Public Consultation Otford Primary School
KCC/SE/0439/2012

Following the public meeting/consultation evening held at Otford Primary School and the recent publication of your planning application to expand the school, I wish to make the following observations.

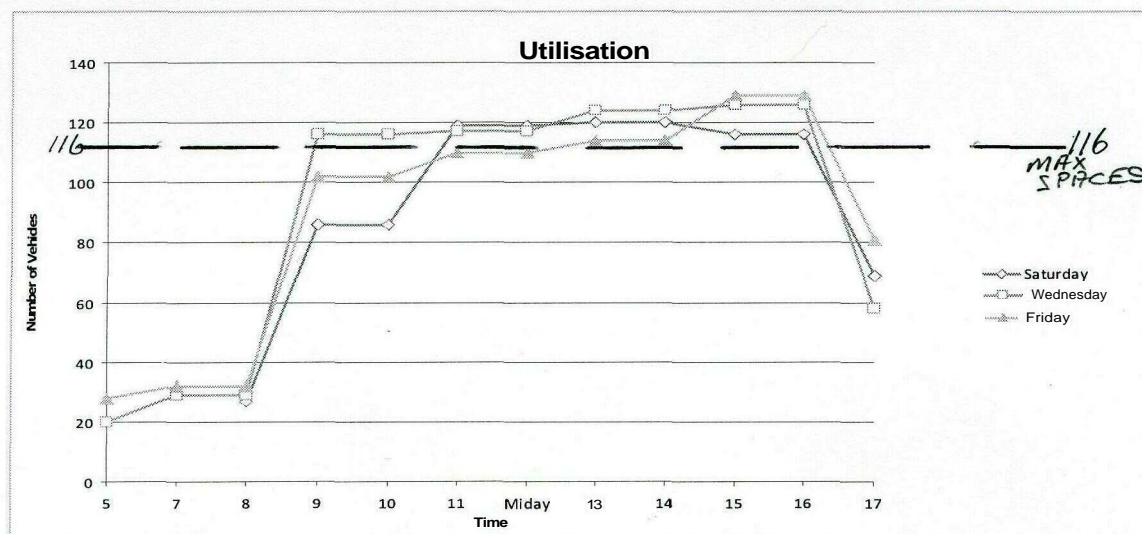
The pie-chart below was collated at 9.00am over 3 weekday mornings and presented to the parish on June 29th 2012. There are 28 residents vehicles in the car park overnight (figures verified at 5.30am, and 6.30 am). 14 remained at 9.00am.

From the dotted line indicating the 116 parking spaces available, you can see that the car park is currently over utilised between 8.45am and 4.00pm
